Architectural Review Board Agenda
4:00 PM Wednesday, April 3, 2024
Sussex Civic Center – Committee Room Second Floor

TO: Architectural Review Board
FROM: Gabriel Gilbertson, Community Development Director
RE: April 3, 2024 Architectural Review Board
DATE: Monday, April 1, 2024

- IV. **Consideration and possible action on the site plan, architectural plan, lighting plan, landscape plan for a Mr. D's Carwash.**

STOREFRONT ENTRY GRAPHICS
EXTERIOR GRAPHICS PROGRAM
Sussex, WI

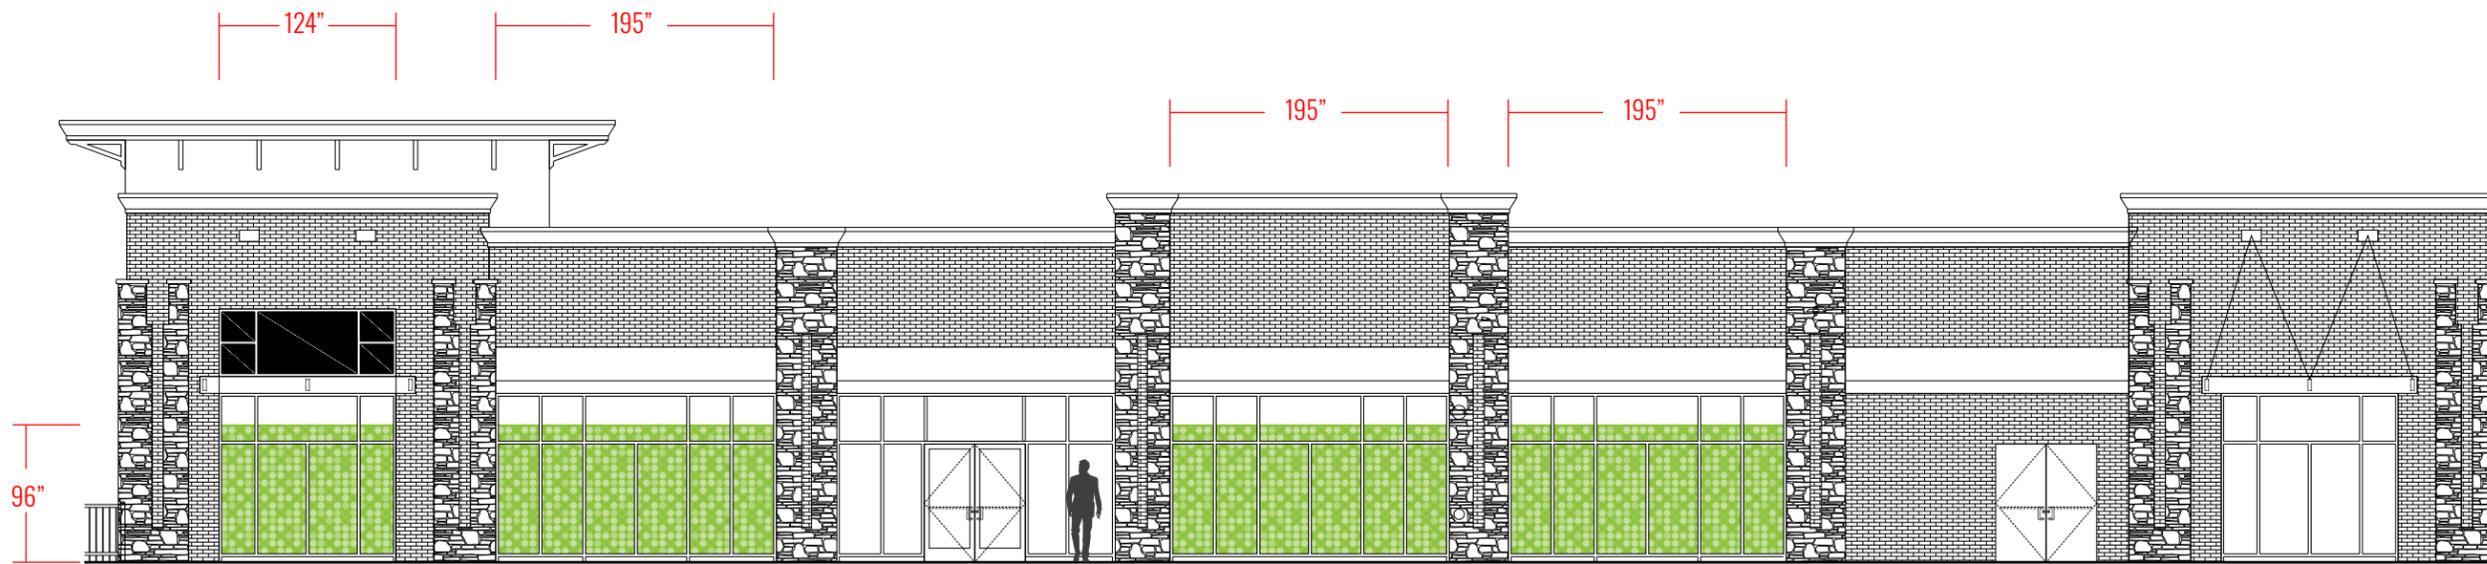
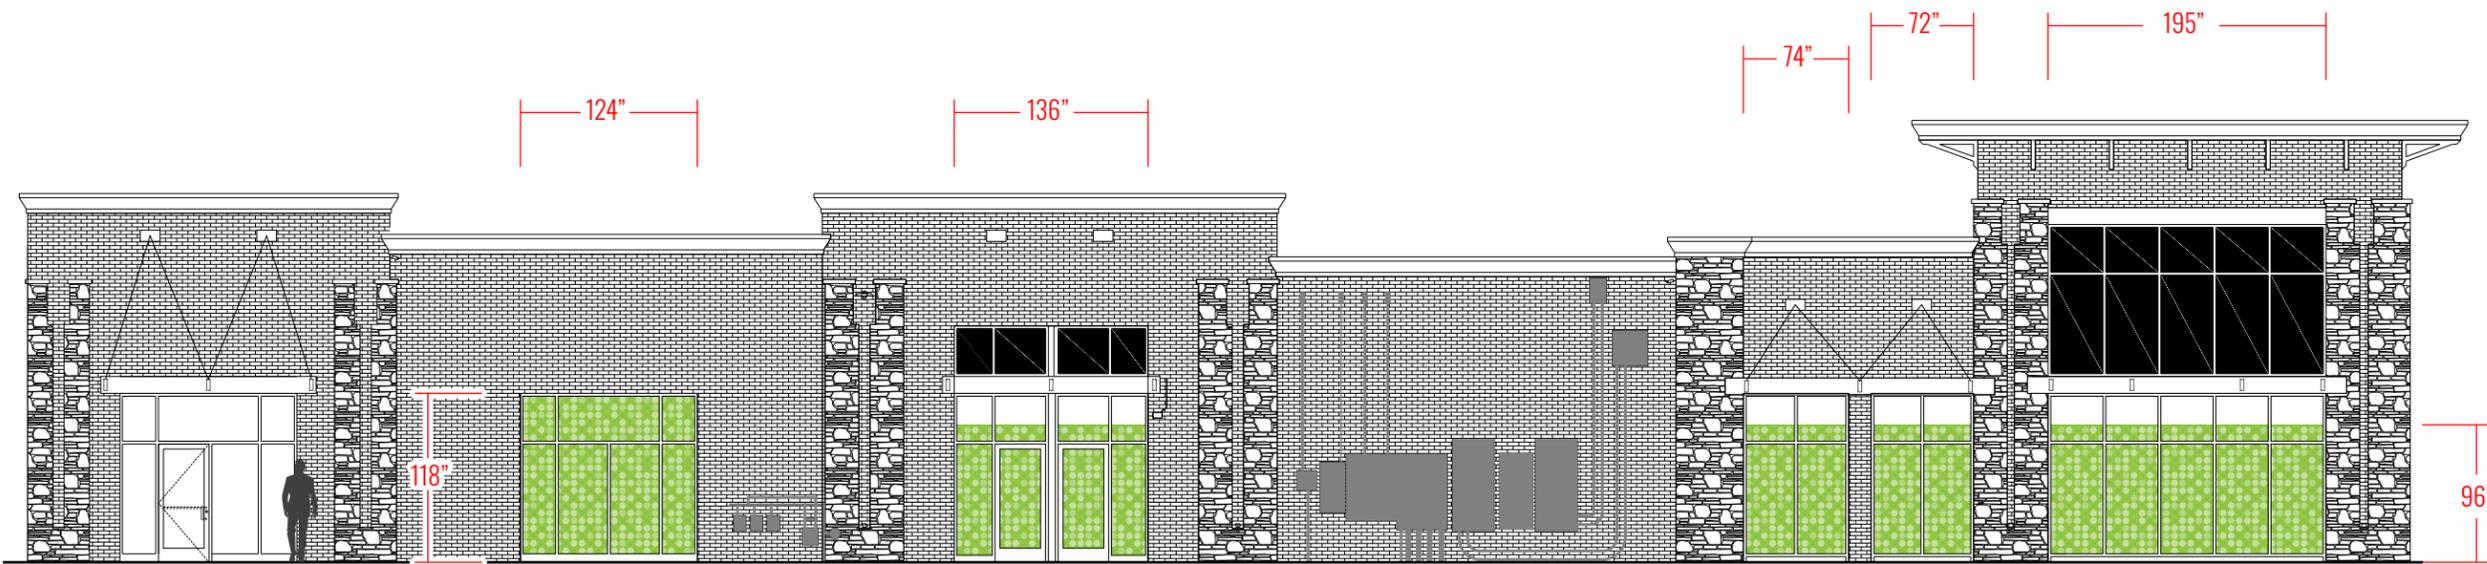
During the renovation, Dollar Tree asked about putting a vinyl on the windows to screen the backside of the shelving units that were installed internally.

1. Are there any concerns with the proposed window vinyl?

Staff Recommendation: Staff recommends the Architectural Review Board discuss the proposed window vinyl to determine if it is appropriate for the development.

SITE DIMENSIONAL & PAVING PLAN

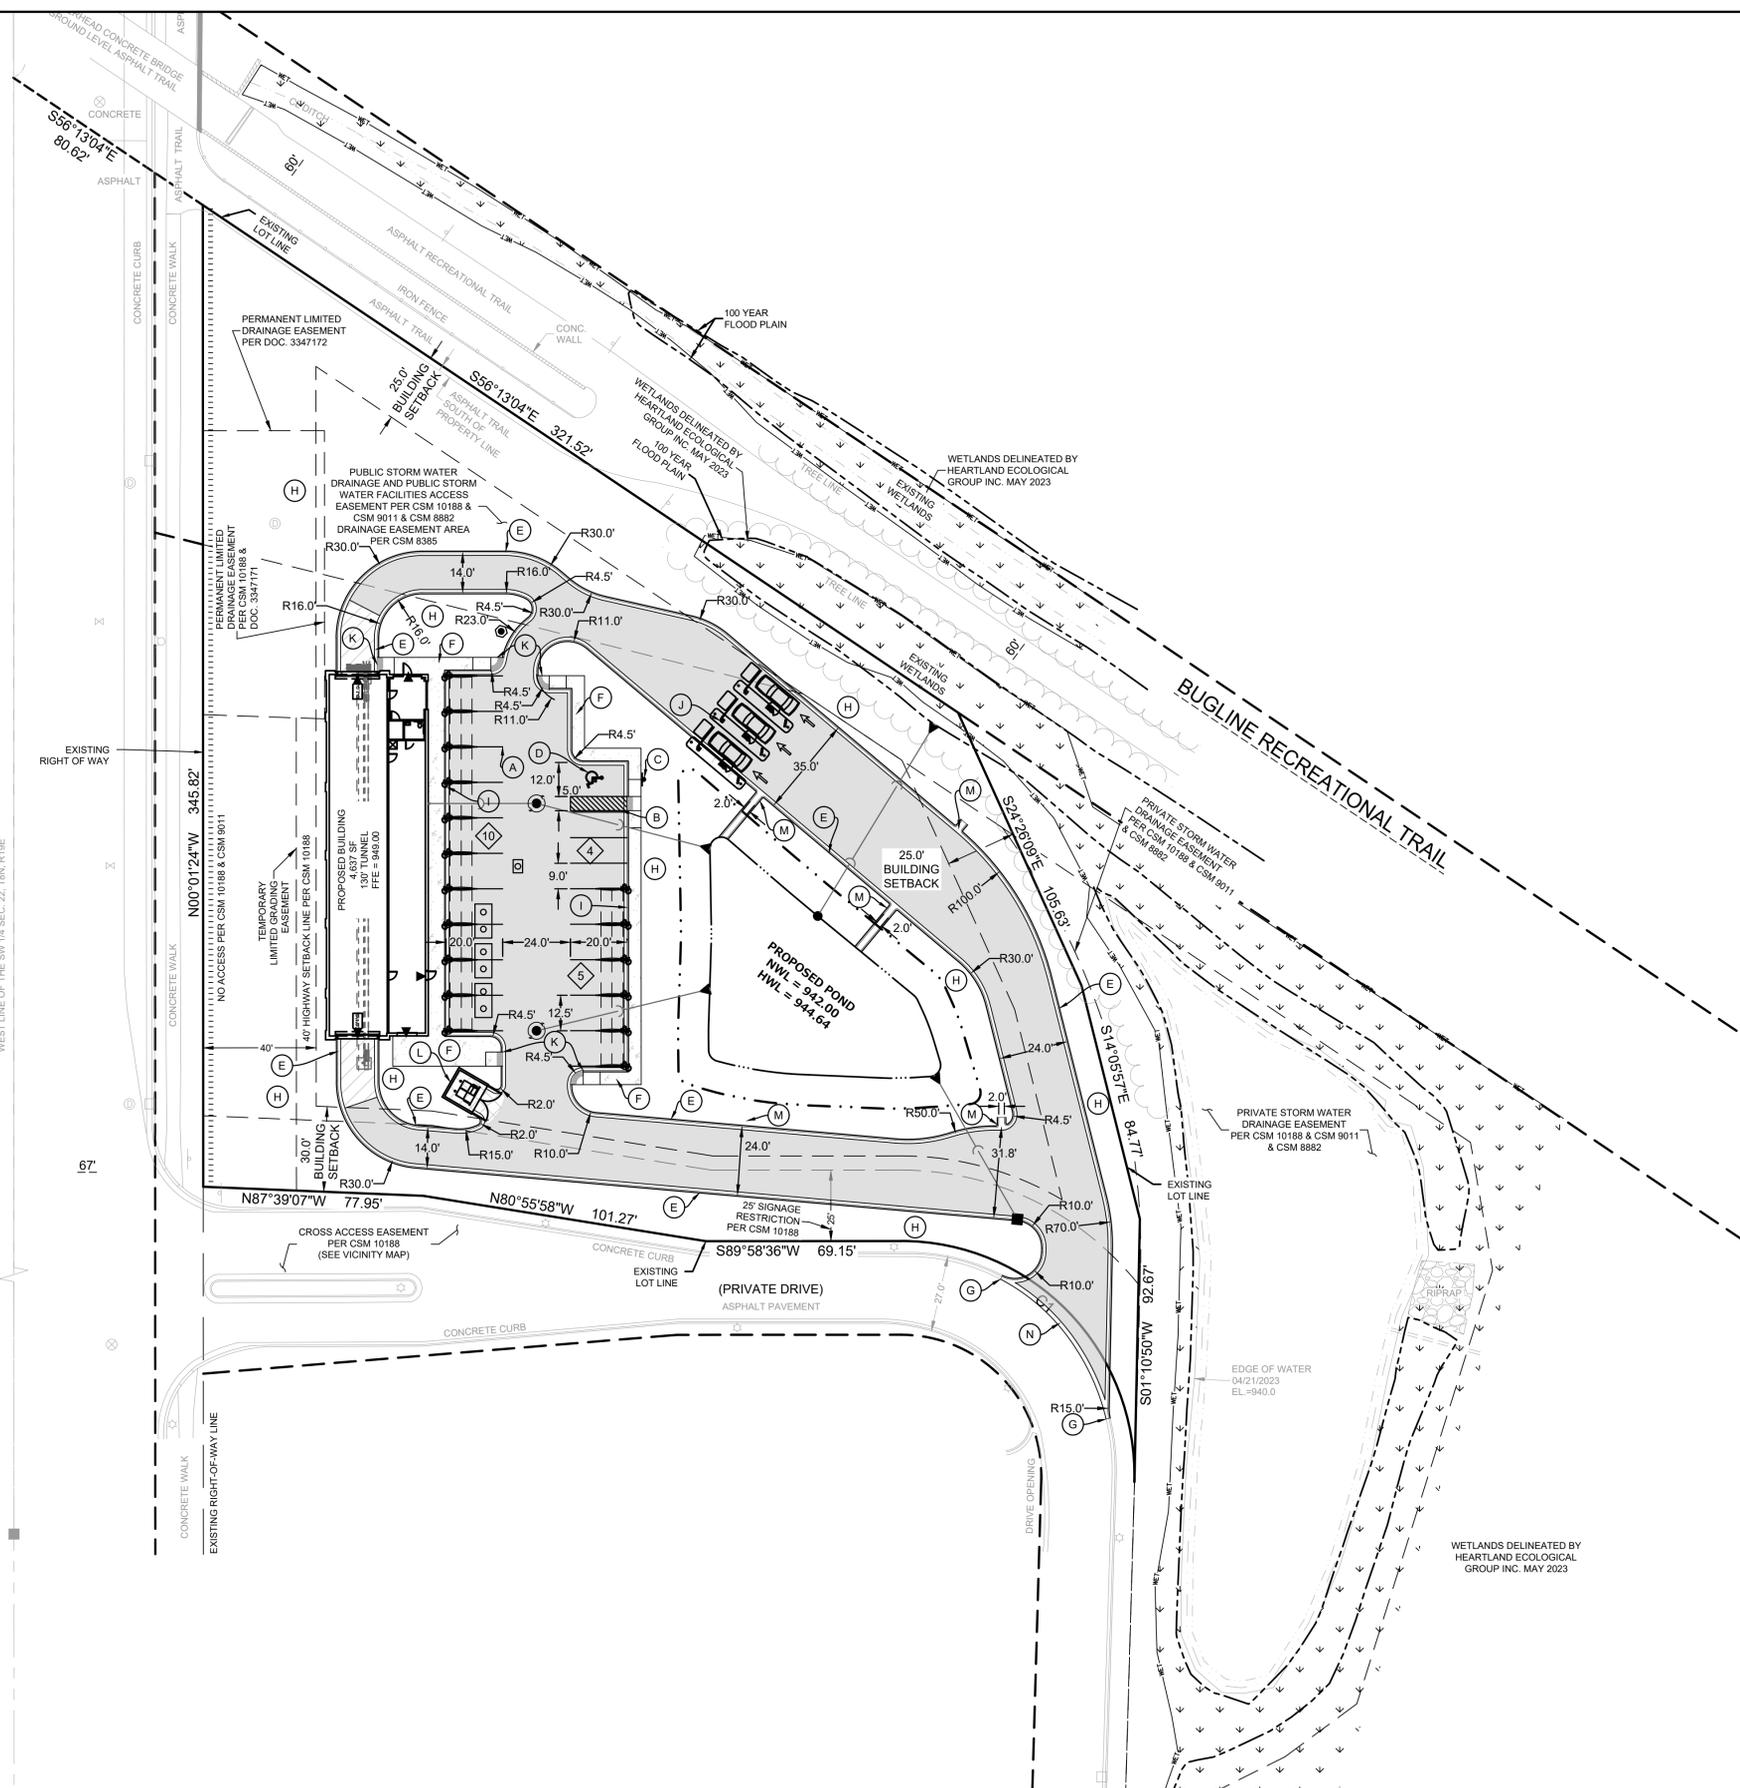
The car wash would be oriented north/south on the west side of the property with vacuum stations on the east side of the building screened from Highway 164. Pay stations and vehicles stacking would also be on the east side of the property. The Municipal Code requires one stall

per employee on the largest shift and according to the application, the largest shift would have 3 employees. The site plan is providing 4 dedicated parking spaces separate from the vacuum stations. The Code also requires enough room for 4 waiting vehicles per washing stall and space for 2 vehicles for vacuuming. There are 15 vacuum stations and space for 15+ waiting vehicles.

- Building meets minimum employee parking and vehicle stacking requirements.

SHEET TITLE:
 ELEVATIONS

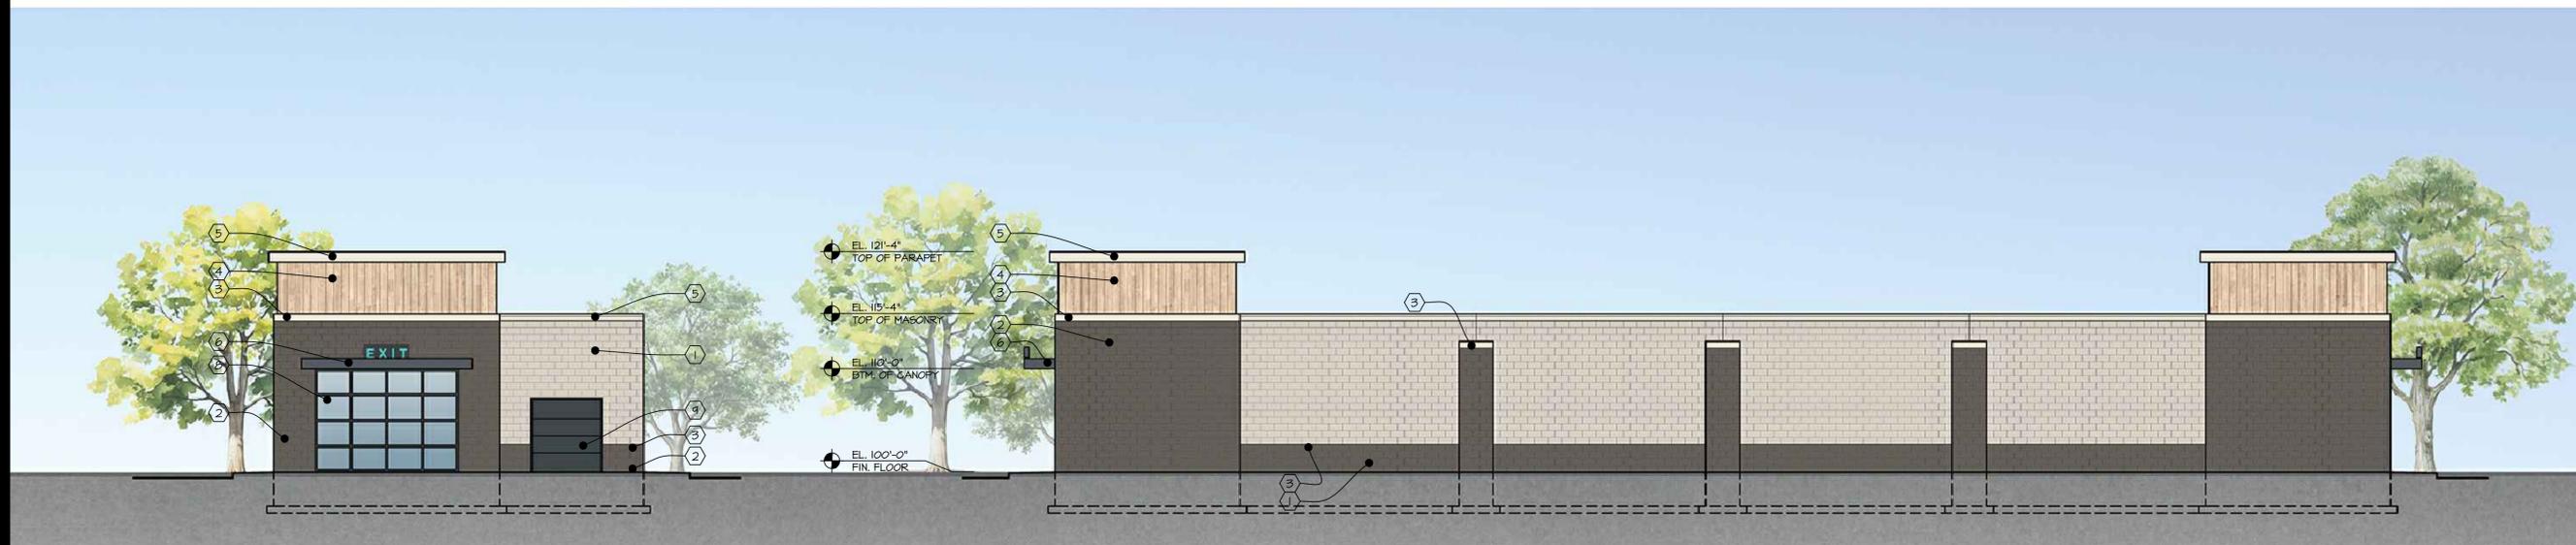
- The building is constructed primarily of concrete masonry units. The use of color and projections will provide some variation to the building's façade.
- A wood-look tile will be used on the tower elements of the building to provide an additional material/color.
- The building meets the minimum height and setback requirements for the Code.
- The submitted plans do not show any roof-mounted HVAC units. If those are to be installed, a plan will need to be submitted to Staff with their locations and methods of screening.
